TECHNICAL MEMORANDUM

Project: Kirkland Parkplace
 Subject: Parking Analysis
 Response to Comments from the Parking Advisory Board
 Date: June 12, 2008
 Author: Marni C. Heffron, P.E., P.T.O.E.

Kirkland Parkplace
Response to Comments from the Parking Advisory Board

Figure 1. Effect of Monthly Downtown Parking Price on SOV Share

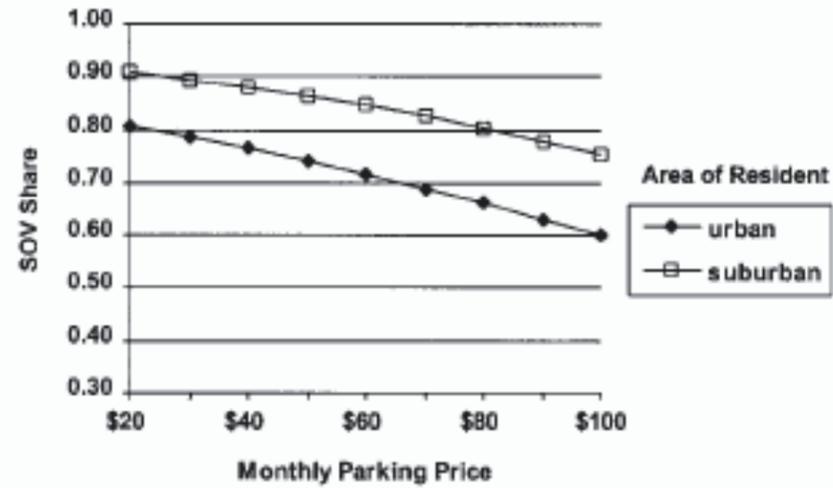
Comment 2. Provide evidence of the price effect on the office parking demand.

Response: Research supports the notion that the price of parking is the most important factor in increasing transit usage. A Transportation Research Board report, *Strategies that Attract Auto Users to Public Transportation*¹ states, “Cities with restrictive parking practices, including higher parking prices, tend to have better transit service and higher transit ridership rates. Change in factors related to parking price have a stronger effect on mode choice than do factors related to transit service.” It also states that, “increasing parking prices for employees is more effective in reducing SOV travel than any of the other pricing strategies examined.” The chart below was excerpted from this report, although it reflects an urban work location, it shows that the price of parking does have a positive effect in reducing SOV travel.

The mode of travel assumed for the analysis is based, in part, on the existing experience in Kirkland. There are few employers in Kirkland that now charge for parking. Therefore, it is likely that when employees are charged to park, the SOV rate would be lower than currently experienced.

Figure 2. Seasonal Fluctuation in Parking Demand

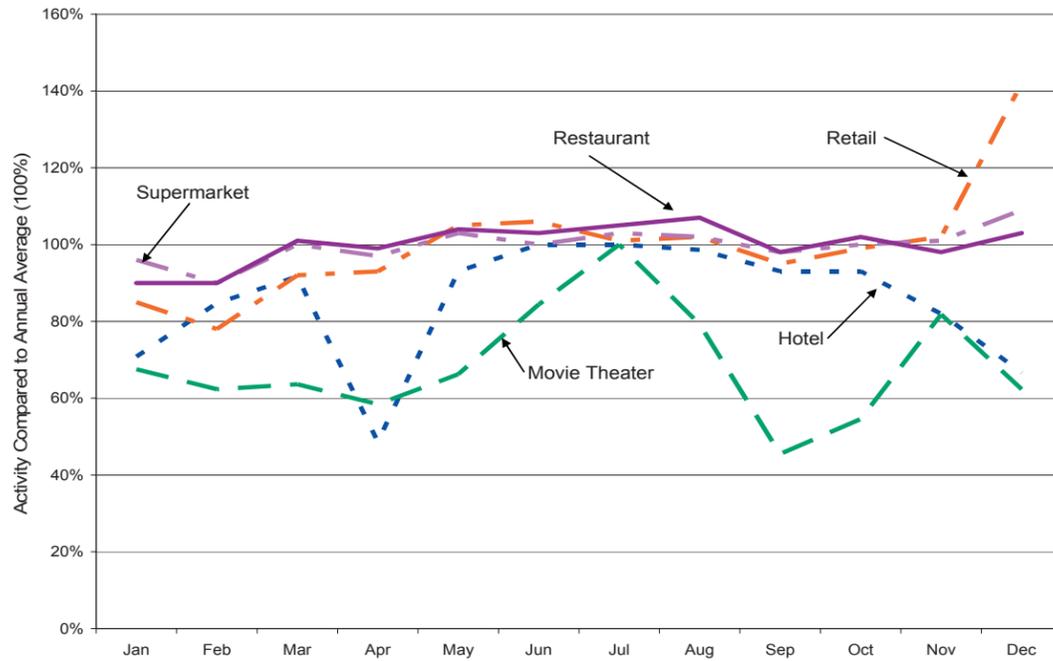
Comment 4. The applicant should provide more evidence of frequency of peaking and appropriate occupancy rates so that parking congestion does not occur more than thirty (30) hours per year.

Response. The individual land uses at Parkplace will have peak parking demand that varies by time of day, day of week and season of year. Figure 2 shows how parking rates for various land uses change month to month. These data, from the Institute of Transportation Engineers' (ITE) *Parking Generation*, reflect how the parking rates compare to the average parking rate. This shows that the peak activity for restaurants, the movie theater and the hotel occurs in the summer. Movie theater activity reaches its maximum peak on the day after Thanksgiving and during the week between Christmas and New Year. However, these are holidays when office parking demand is low.

Retail activity spikes from mid-November to mid-December. During this season, movie theater activity and hotel activity are lower than normal. Anecdotal information suggests that health club activity drops in December (it then peaks in January). There is also no seasonal activity data available for office uses. However, parking demand tends to be lowest during peak vacation periods in the summer and around the holidays.

The data show that the highest parking demand is likely to occur in December when the supermarket and retail activity increases to its highest level of the year. Retail peaks that occur midday on weekday are expected to be very limited; the highest retail demand is still likely to occur in the evenings and on weekends when most office parking on the site would be available for customers.
